ENHANCEMENT OF PRODUCT APPEAL

SEAT

1. Front Seat

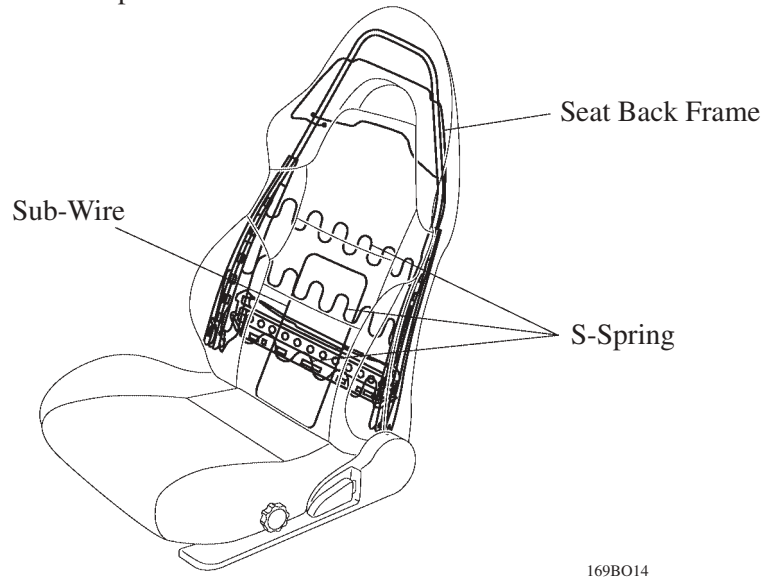
- The placement of the S-springs on the seat back has been optimized, and a sub-wire has been buried in the seat back pad to improve the seat's support and seating comfort.
- A high-density, low-rebound pad material that excels in vibration absorbing performance has been adopted for the seat cushion pad.
